April 21, 2021
20566

Windham Public Safety Rénovation and Expansion Project

Review Comments and Responses:

B
A2

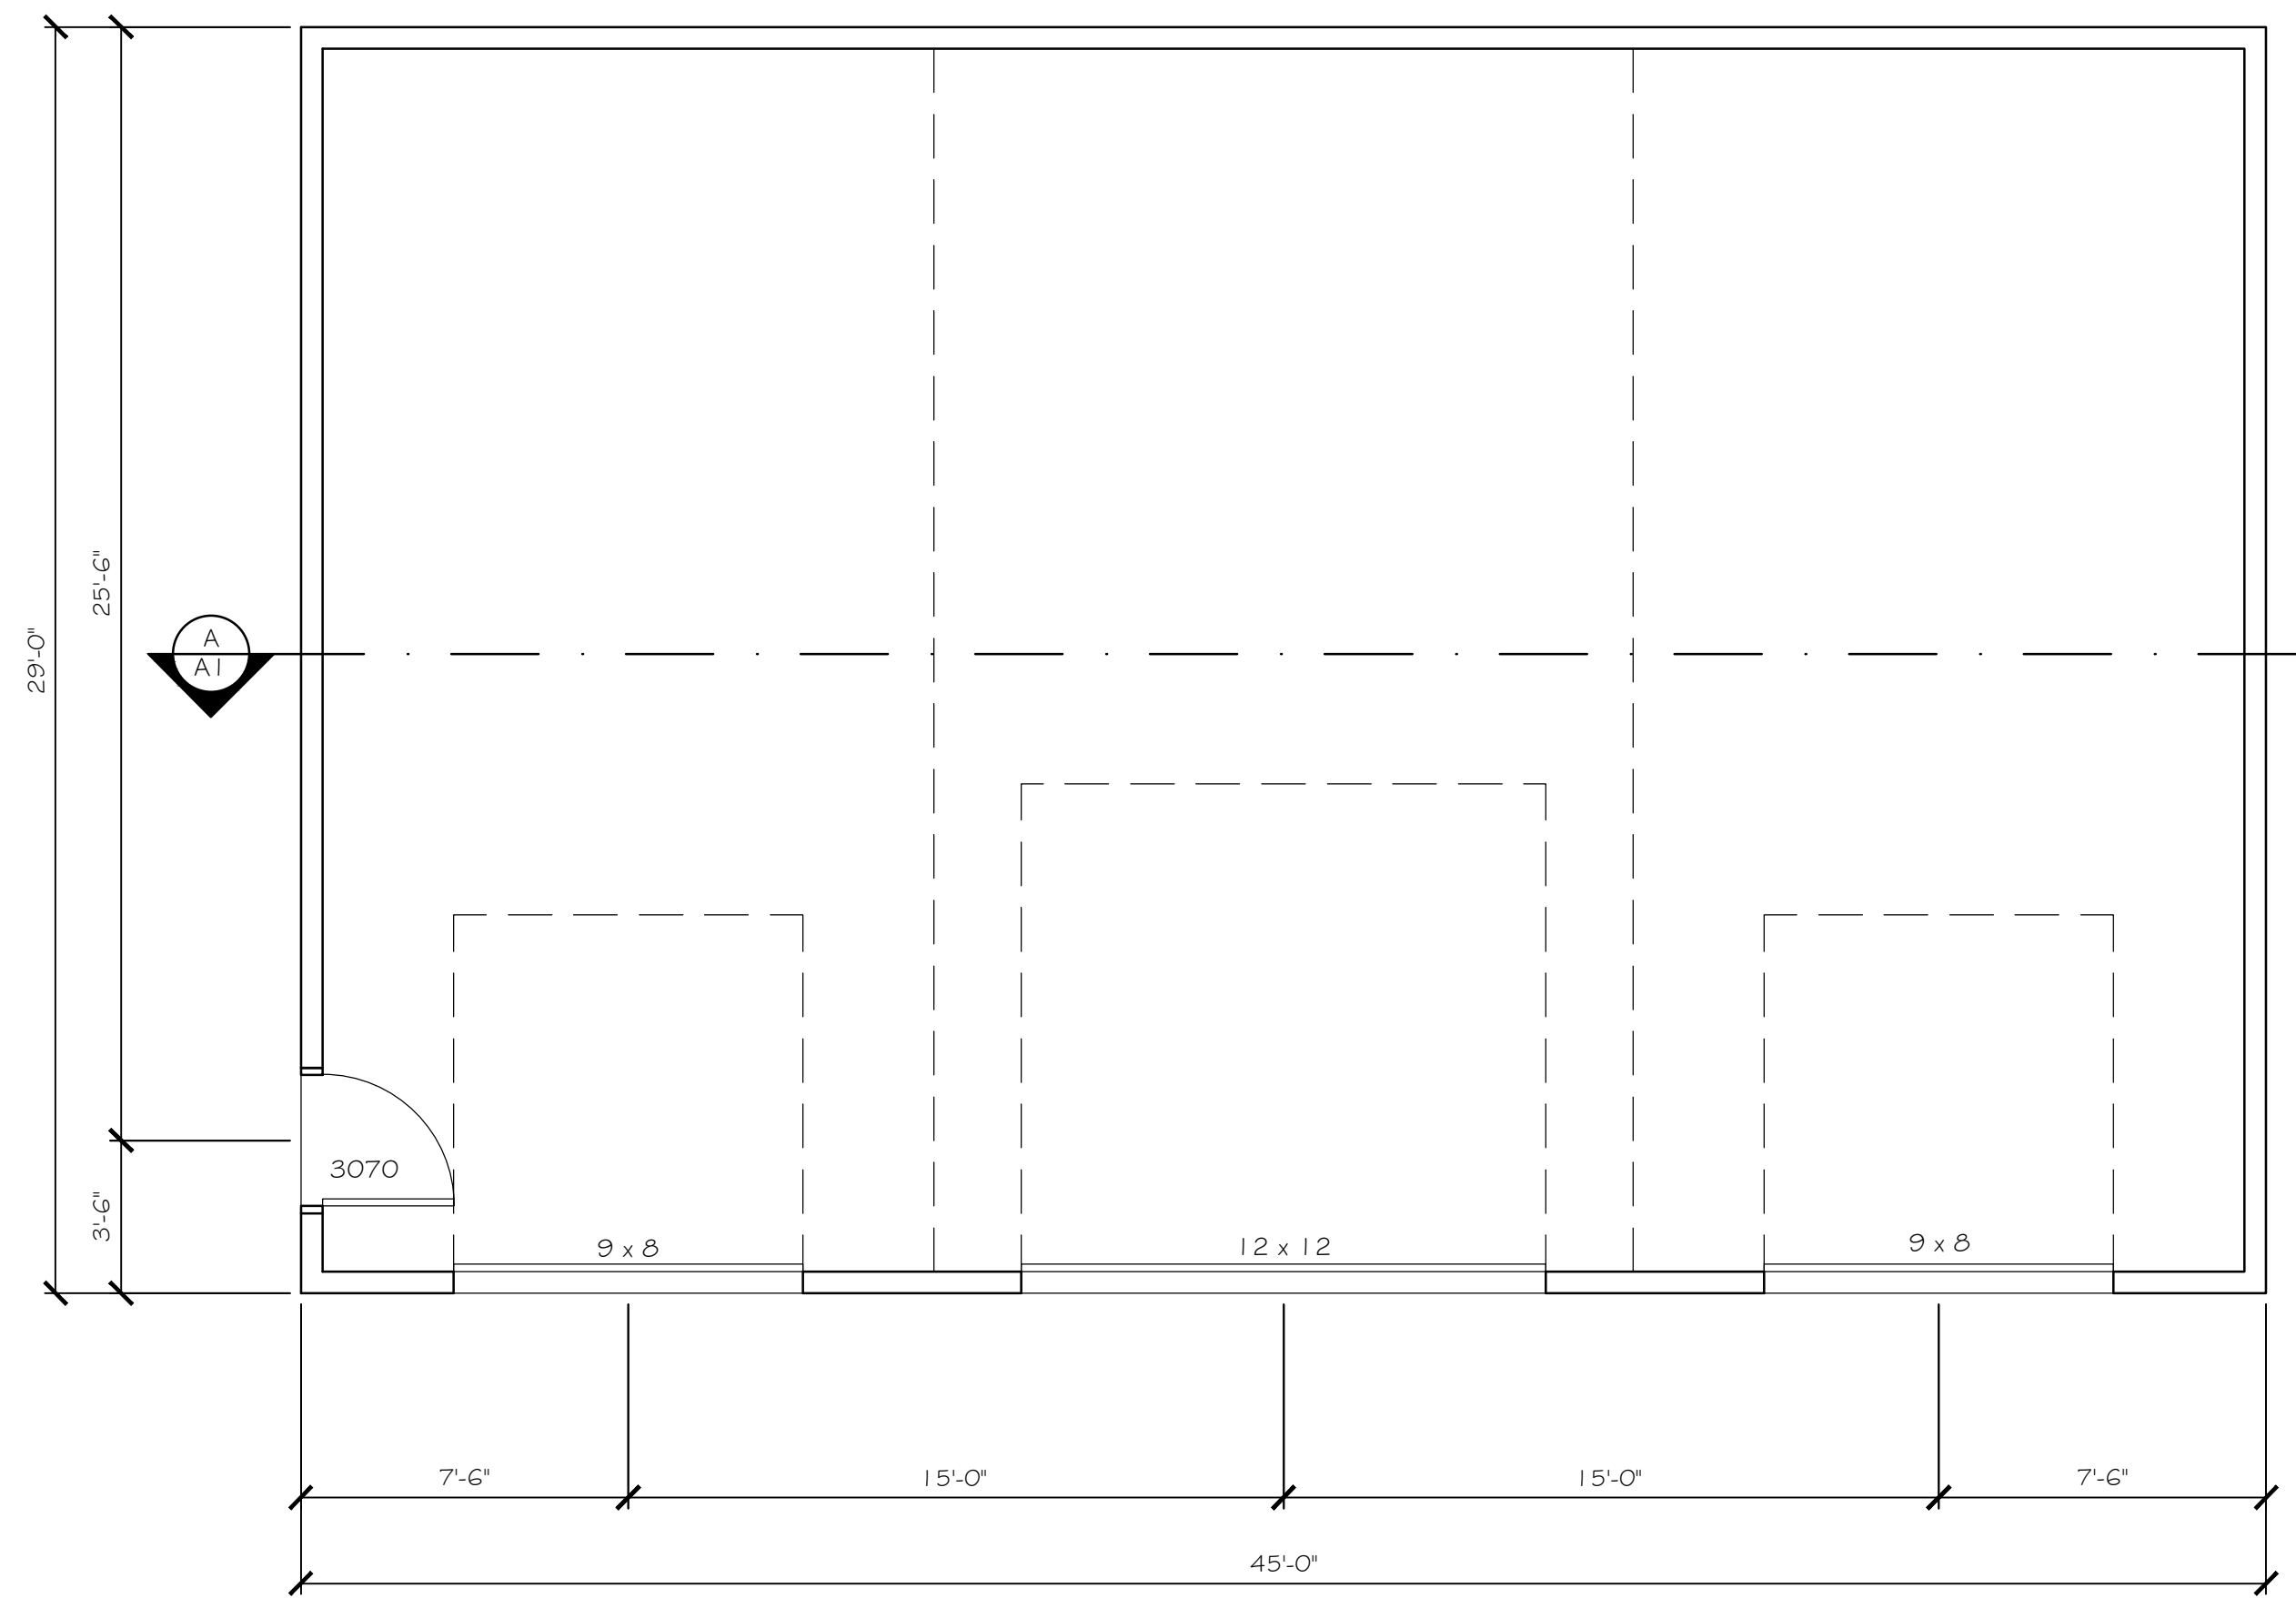
5. Ground floor elevation drawings for the proposed evidence storage buildings.

Response: We have included the architect's plans for the building.

WINDHAM PUBLIC SAFETY BUILDING
WINDHAM, ME
SITE LIGHTING LAYOUT

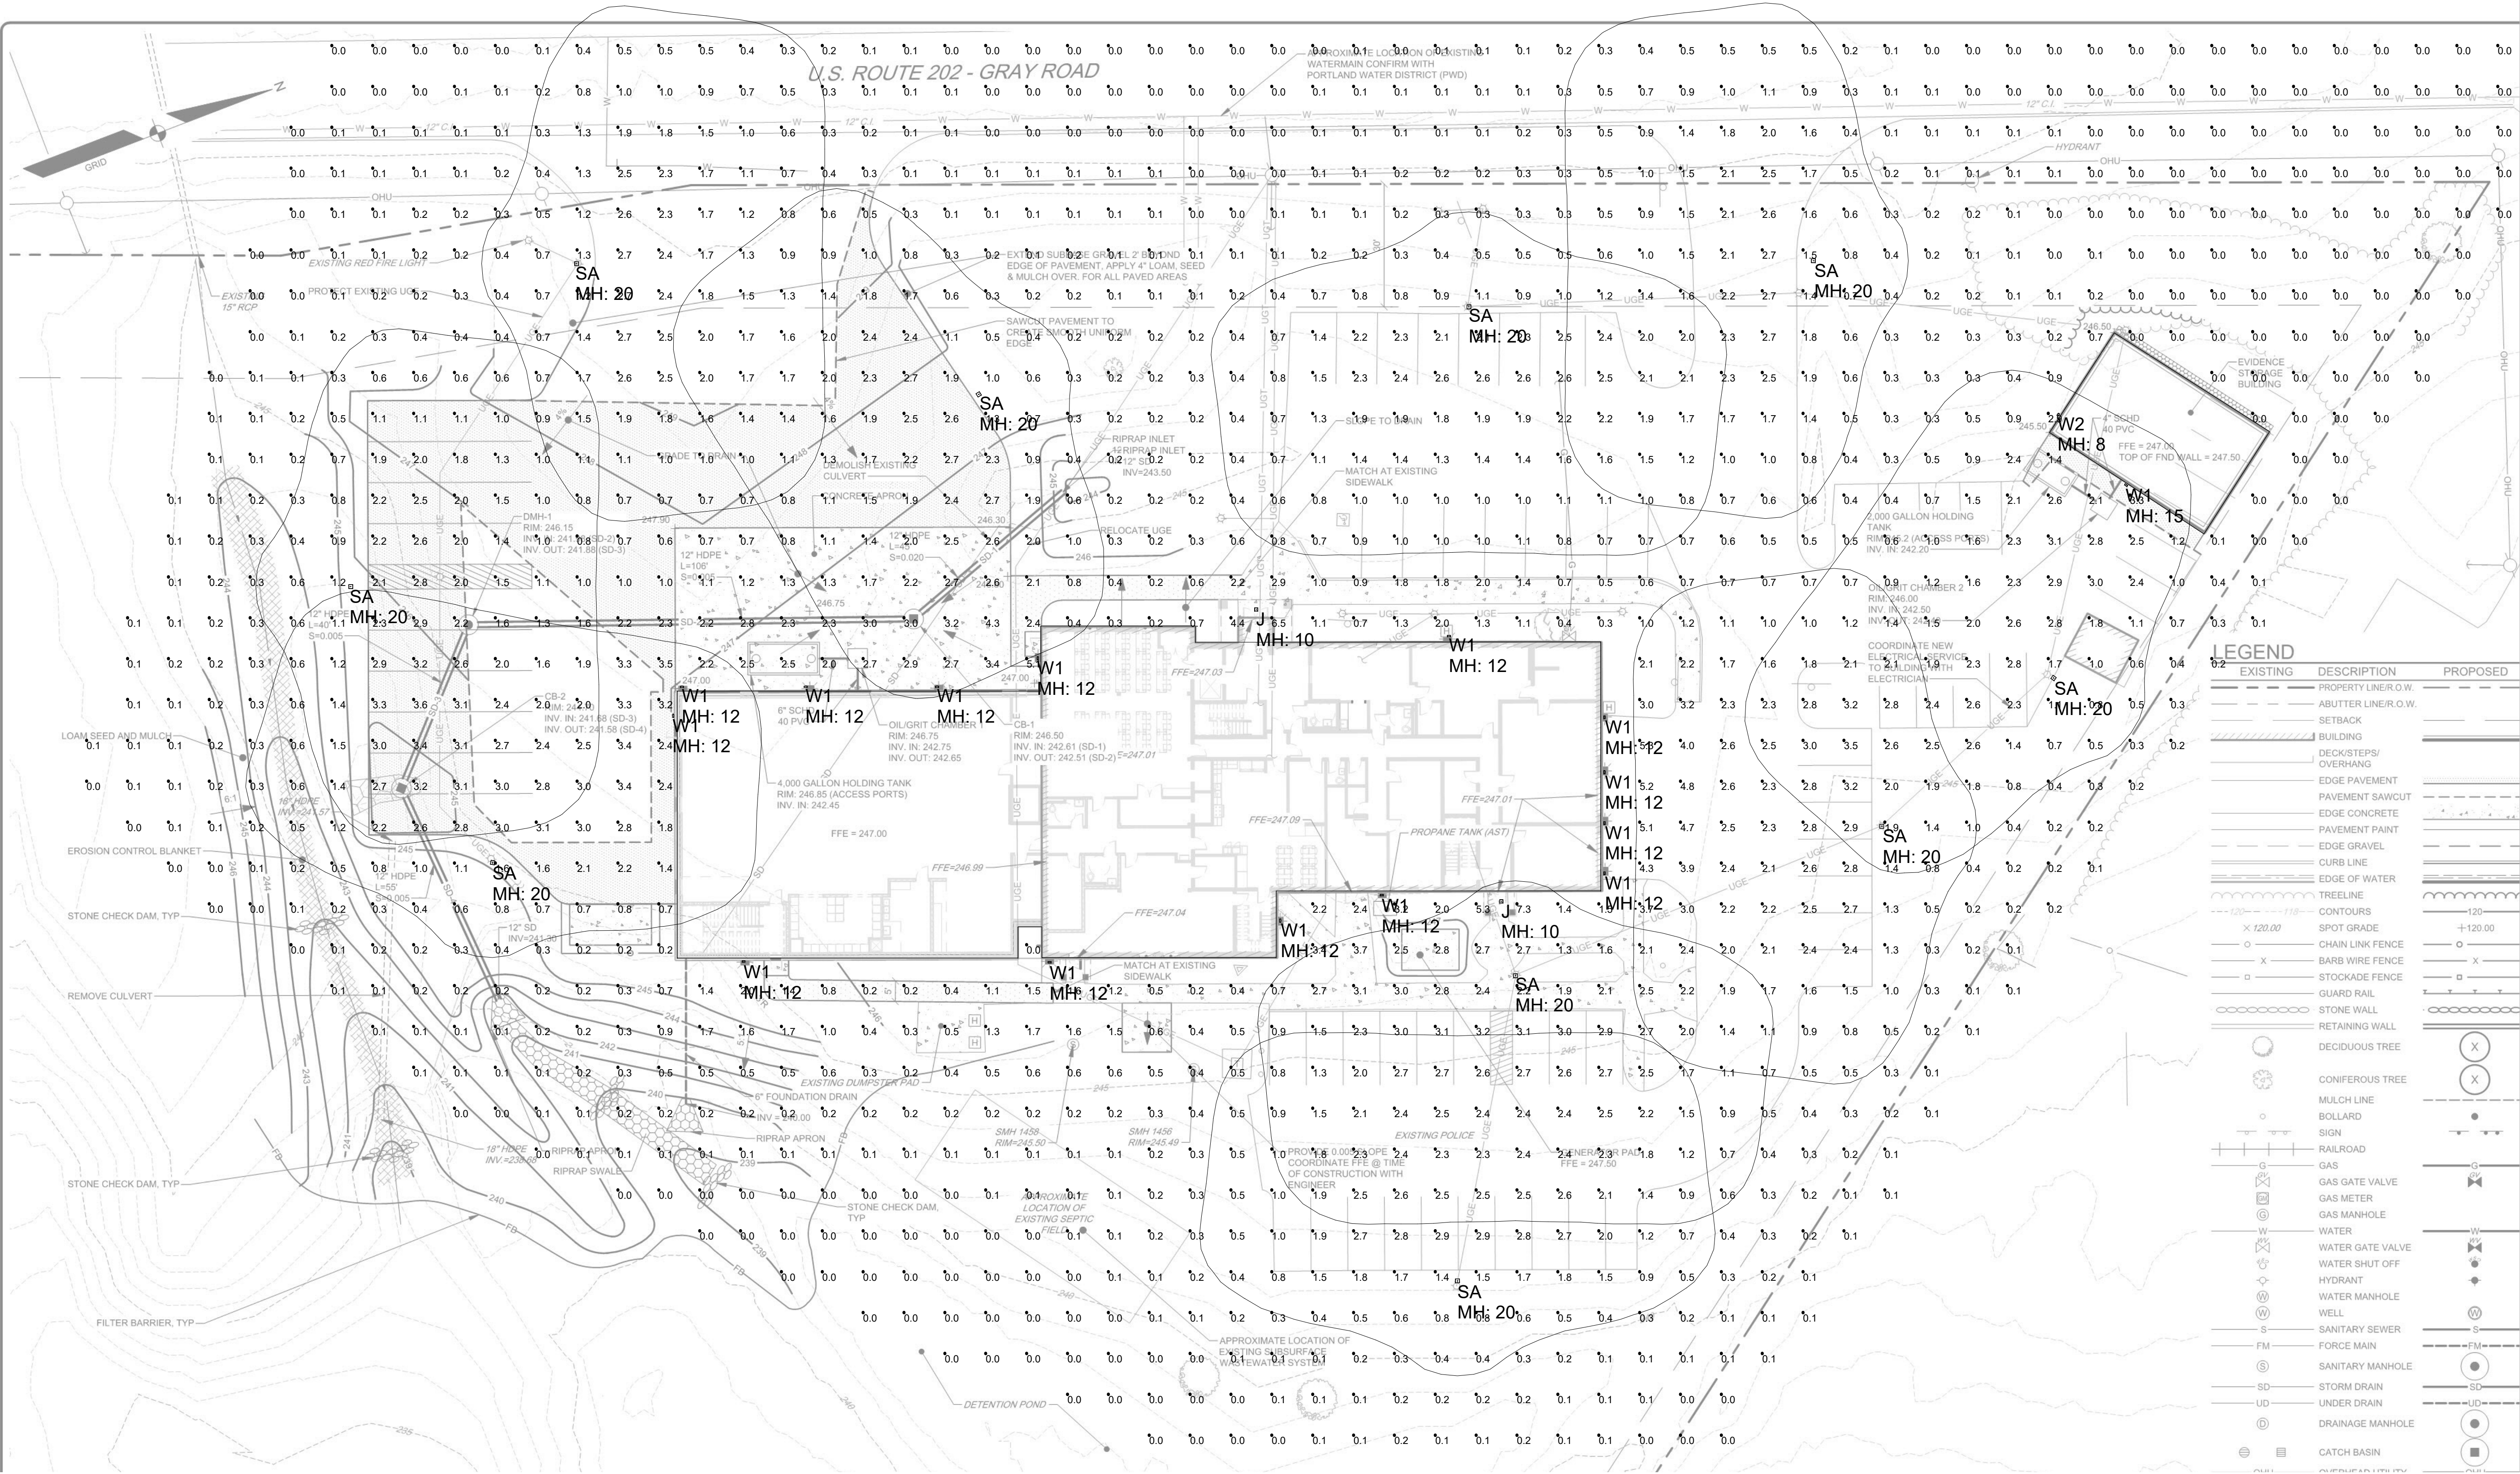
6. Is any lighting proposed on the exterior of the evidence storage building? The building is not shown on the plan.

Response: Supplemental to our original submittal, we have added the building and lights to the photometric plan and have included the updated plan in this submittal.
